**Project: IEEE P802.15 Working Group for Wireless Personal Area Networks (WPANs)**

**Submission Title:** [MSC figures in draft and updated figures status]

**Abstract:** [MSC figures in draft and updated figures status]

# MSC in D1 draft

**Figure 52—Message sequence chart describing the MAC data service**

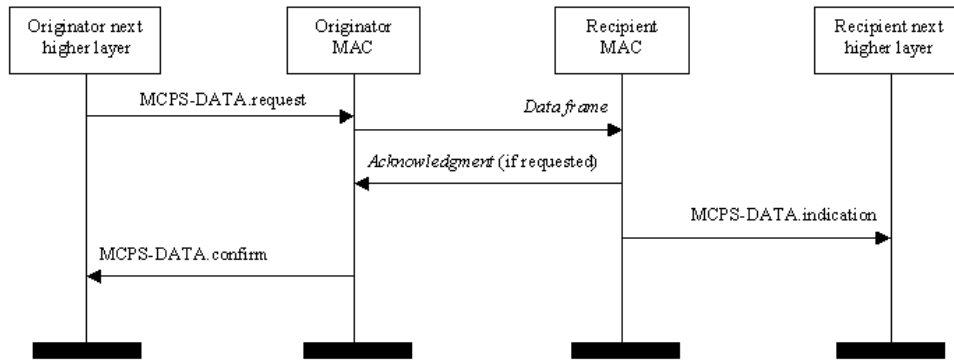
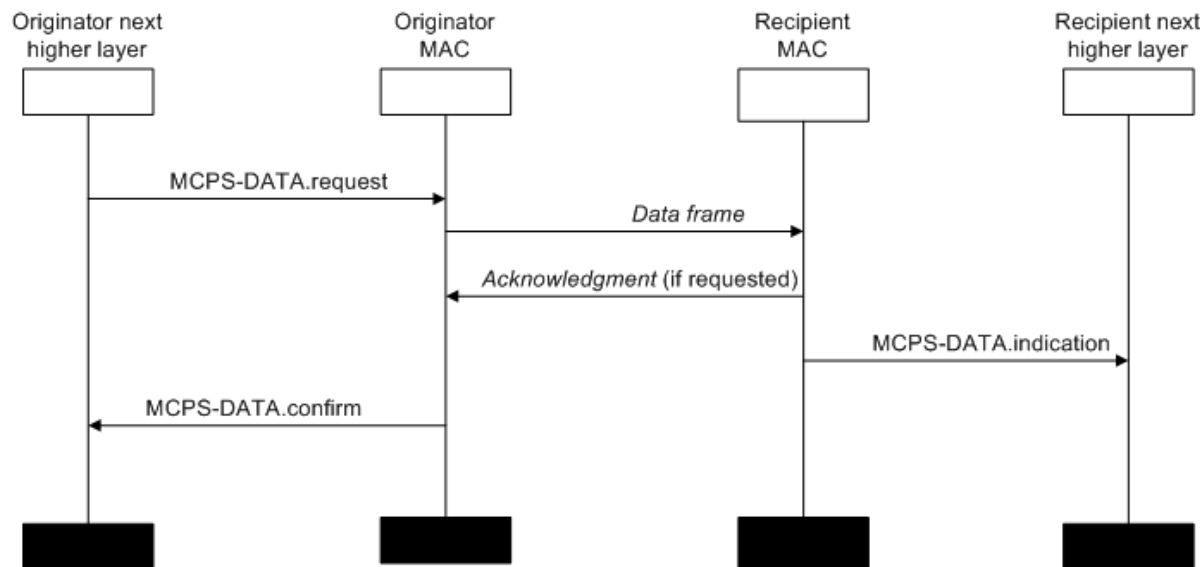
❖ Original figure MSC style : Not exist, Not editable.

❖ made new figure

❖ No change.

Figure 53—Message sequence chart for association

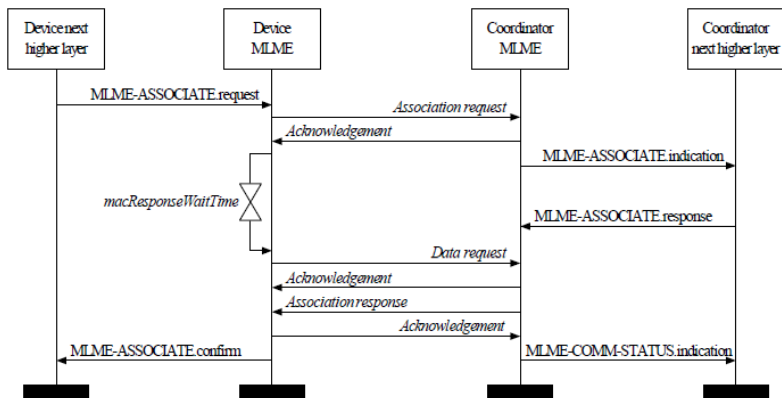
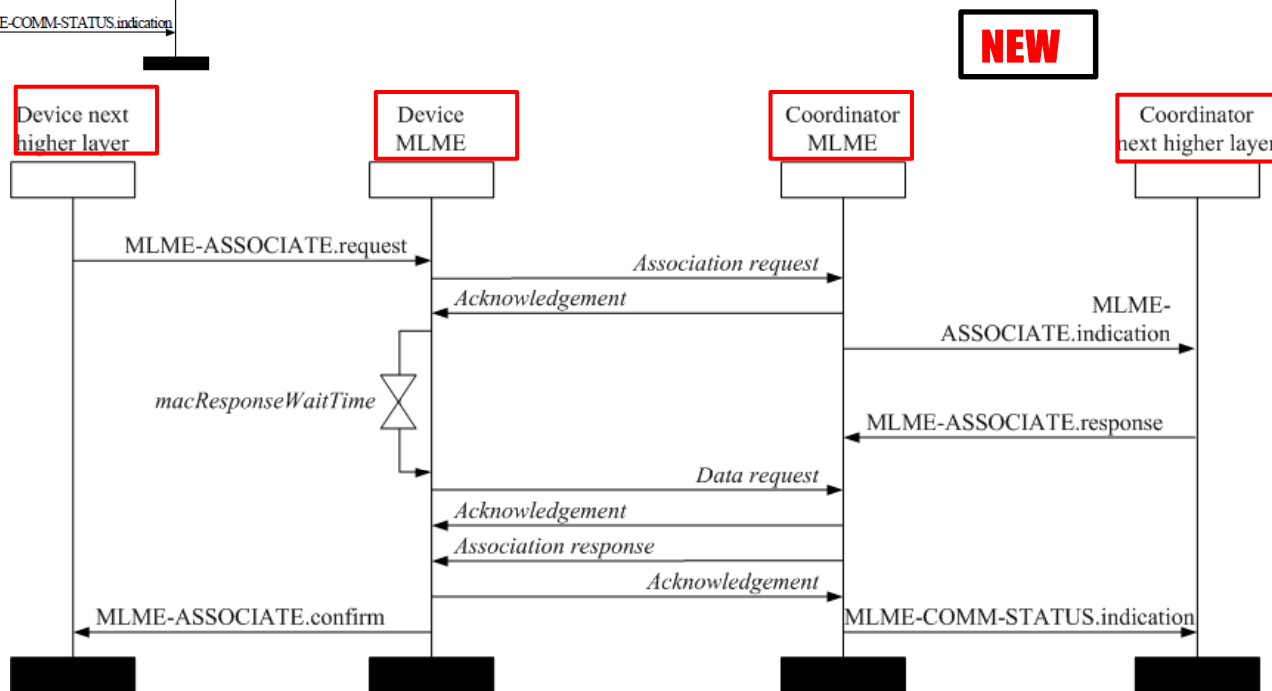
❖ Original figure MSC style :  
editable.

❖ Minor change.

■ Text outside box

**Figure 54—Message sequence chart for disassociation initiated by a device**

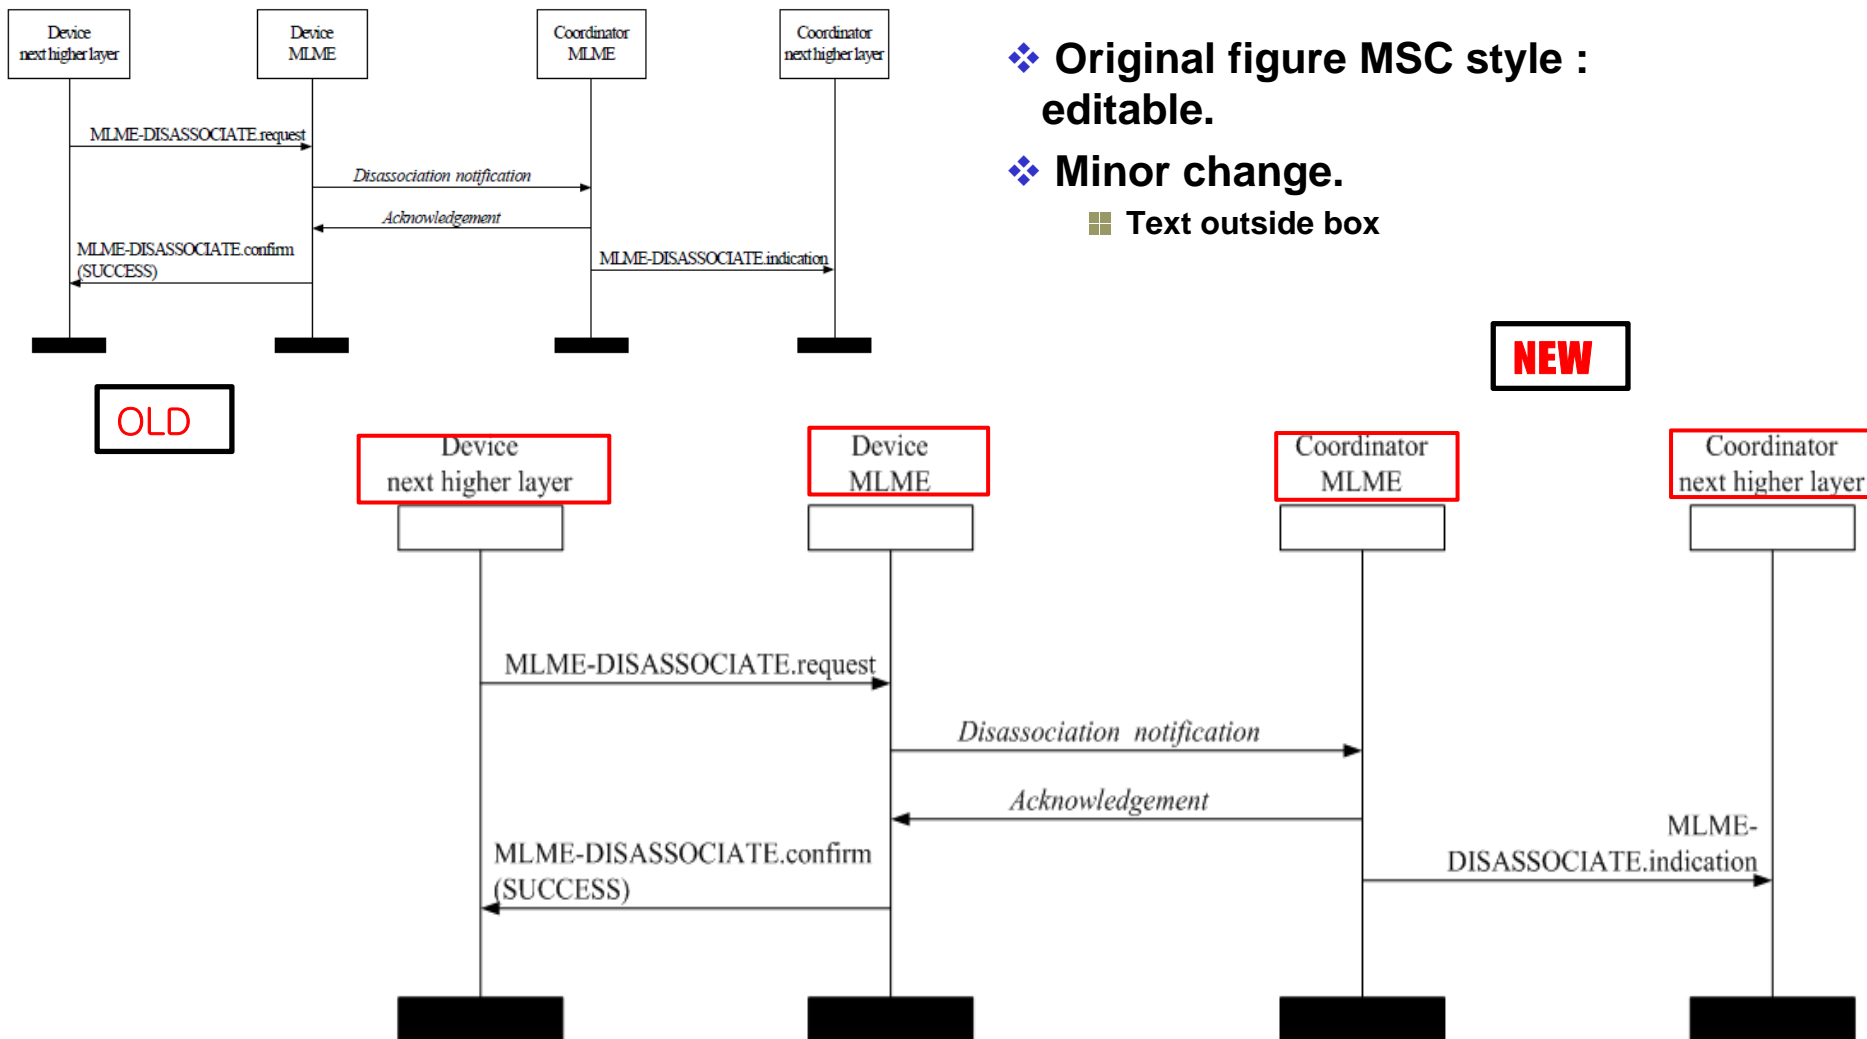
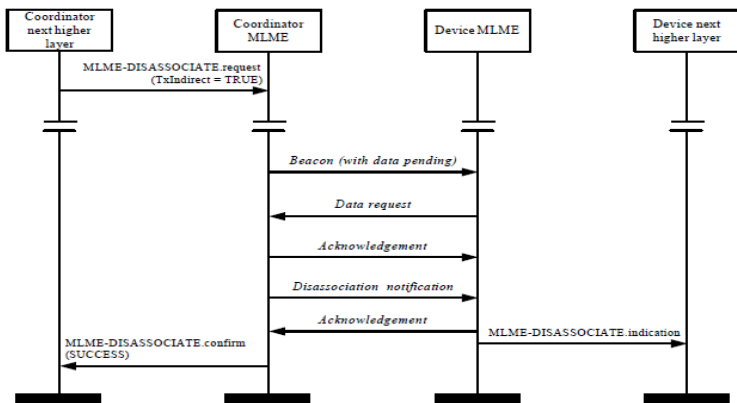
❖ Original figure MSC style :  
editable.

❖ Minor change.

■ Text outside box

### Figure 55—Message sequence chart for disassociation initiated by a coordinator, using indirect transmission, in a beacon-enabled VLC WPAN

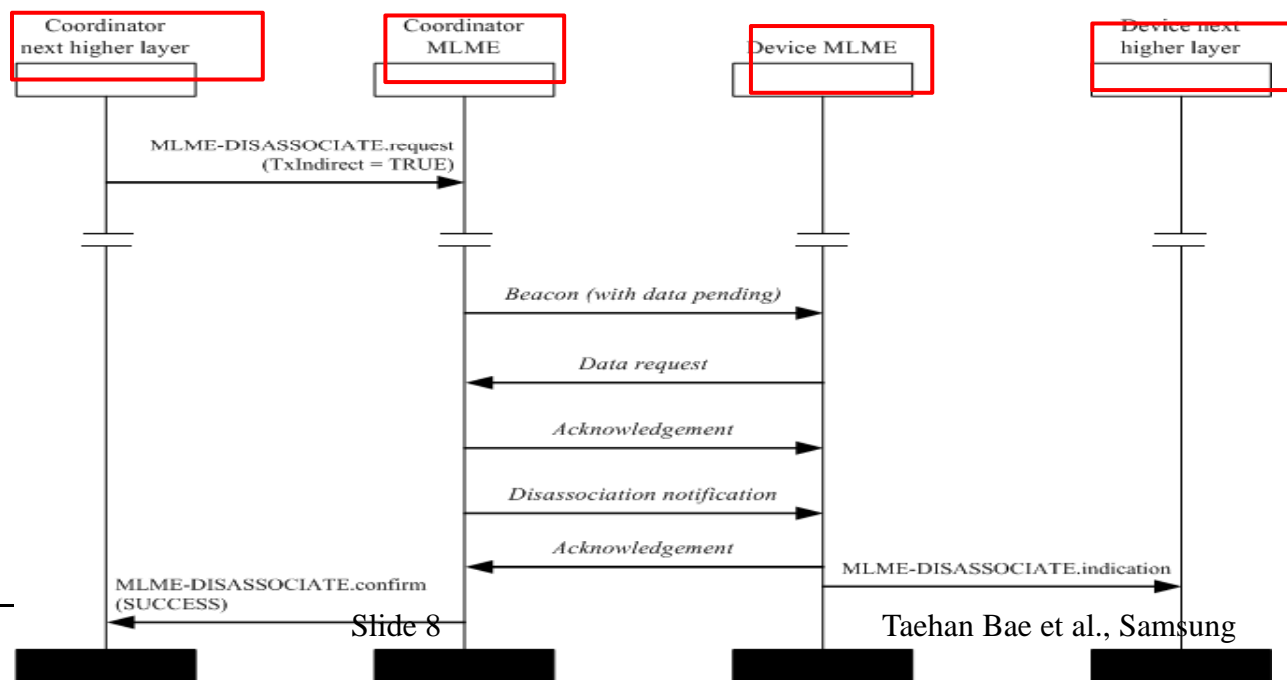
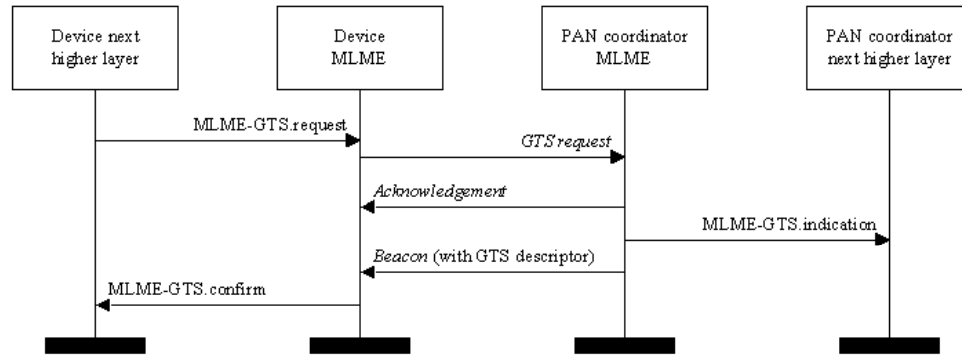
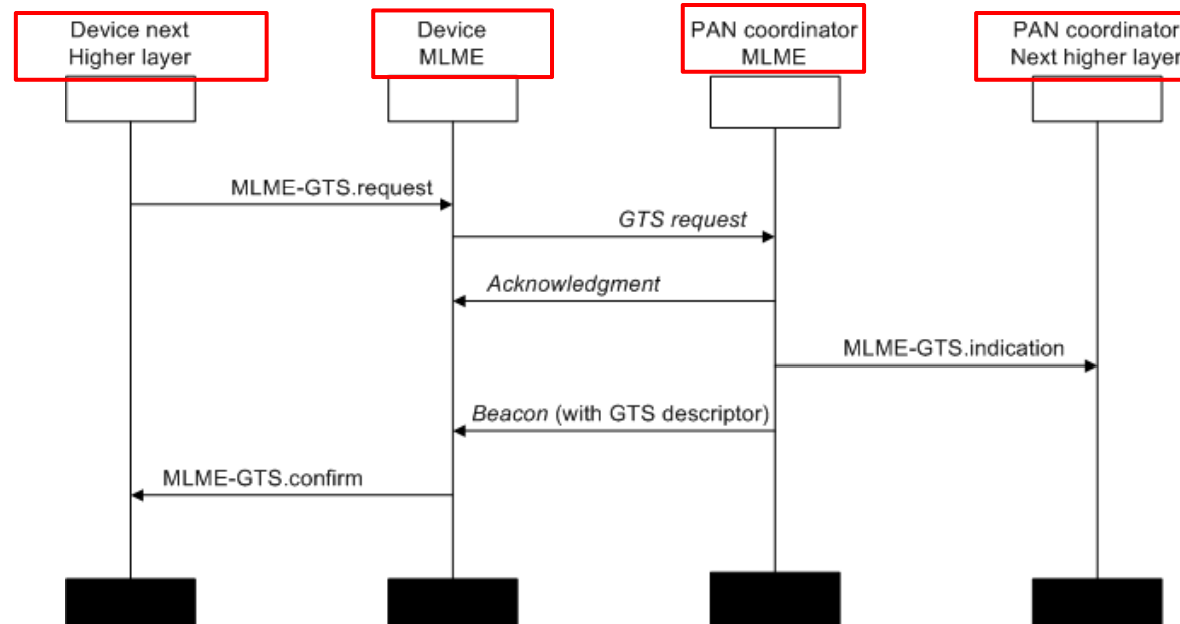
❖ Original figure MSC style :  
editable.

❖ Minor change.

■ Text outside box

**Figure 56—Message sequence chart for GTS allocation initiated by a device**

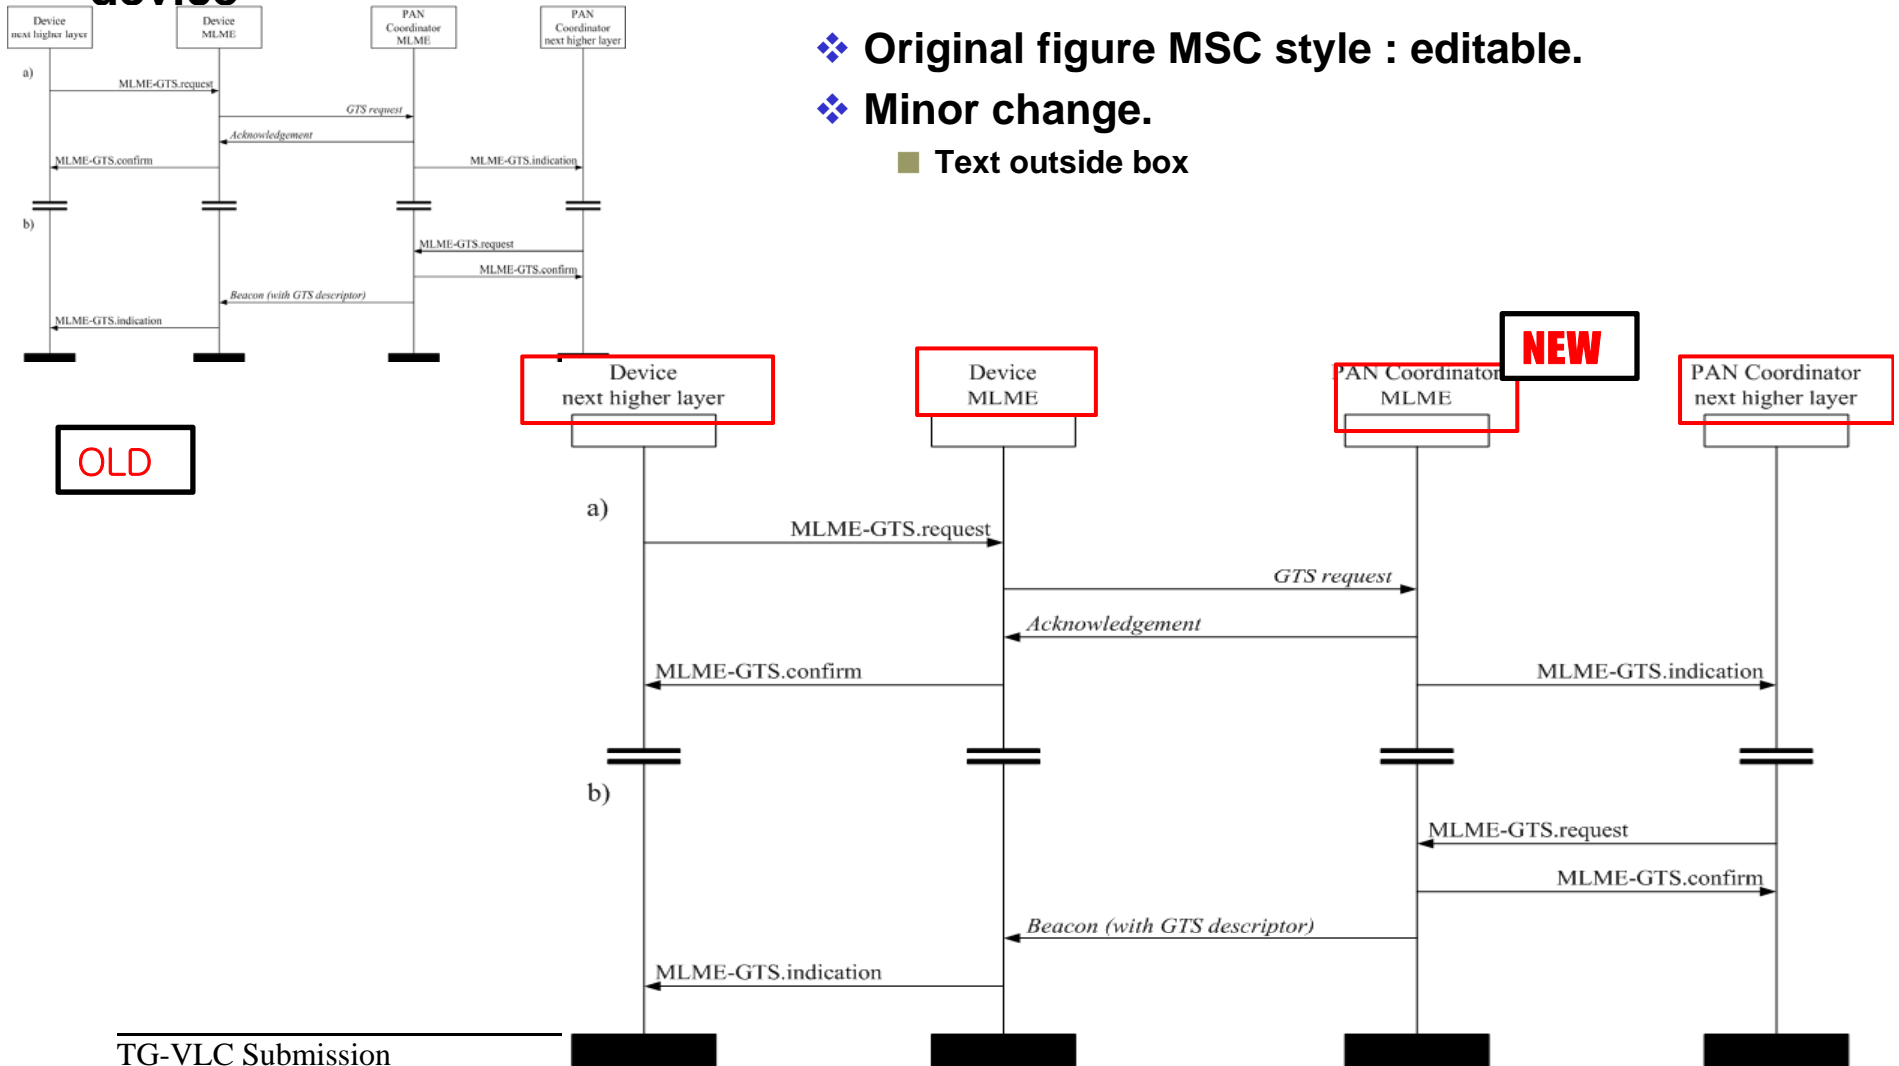
❖ Original figure MSC style : Not exist, Not editable.

❖ made new figure  
❖ minor change.

■ Text place in outside box

**Figure 59—Message sequence chart for updating the superframe configuration**

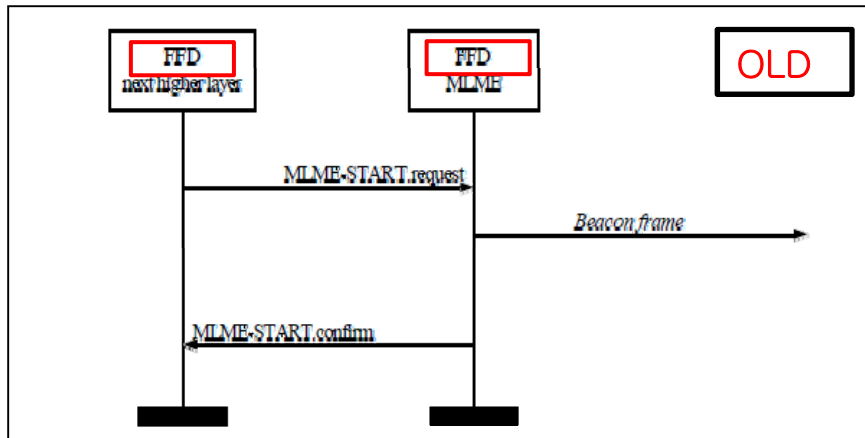
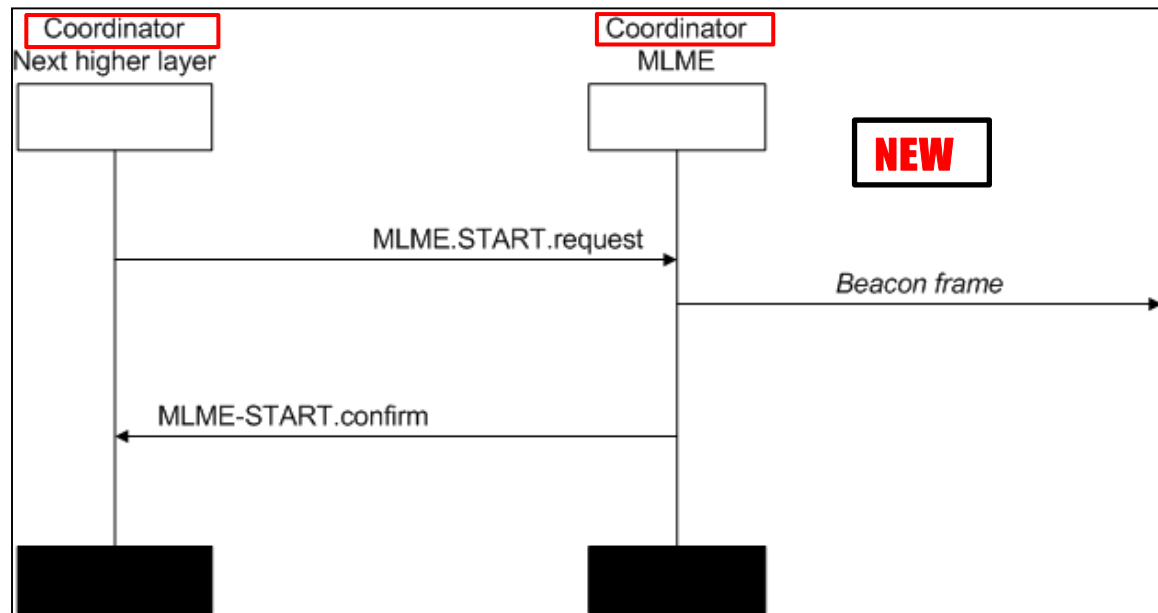
❖ Original figure MSC style : Not exist, Not editable.

❖ made new figure  
❖ change FFD into Coordinator

**Figure 60—Message sequence chart for synchronizing to a coordinator in a beacon-enabled VLC WPAN**

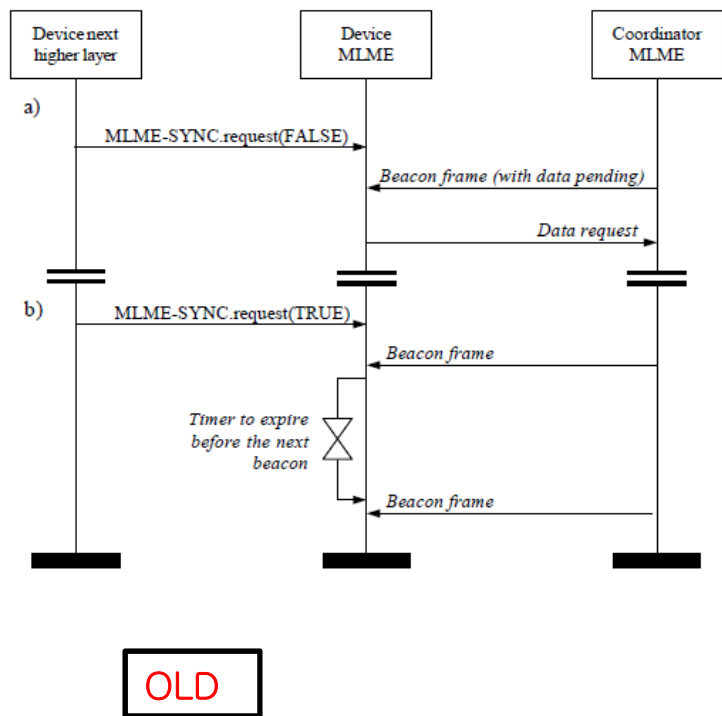
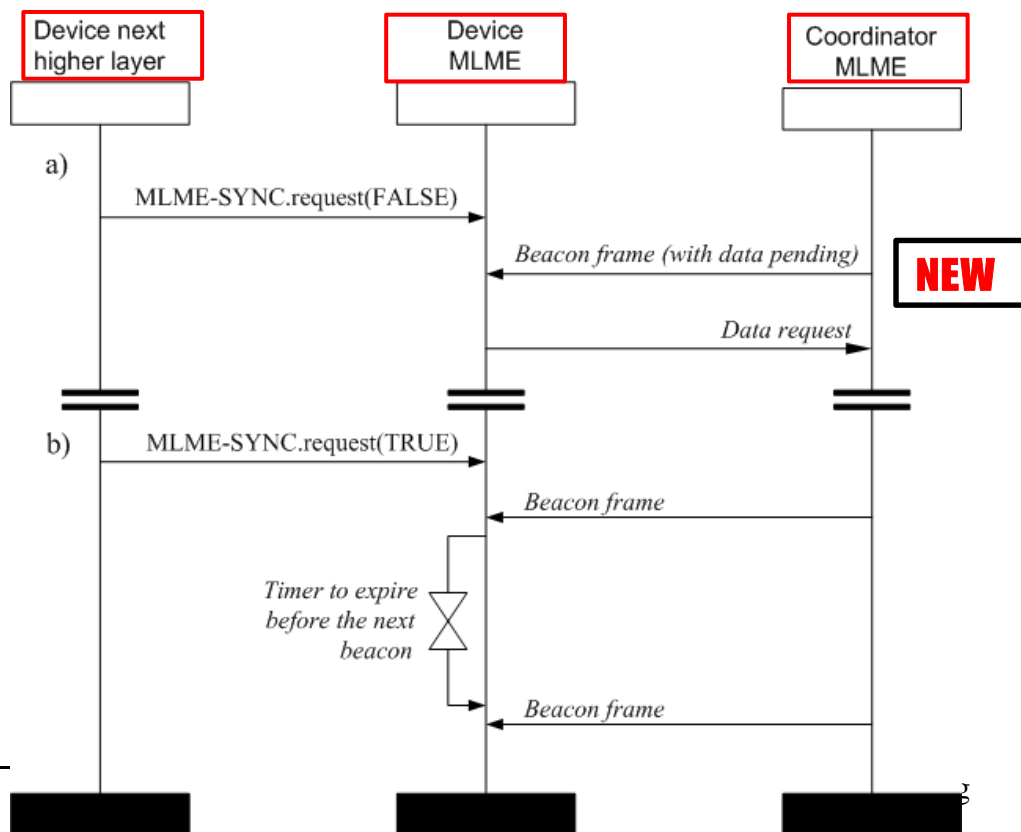
❖ Original figure MSC style : Not exist, Not editable.

❖ made new figure

❖ Minor change

■ Text place in outside box.
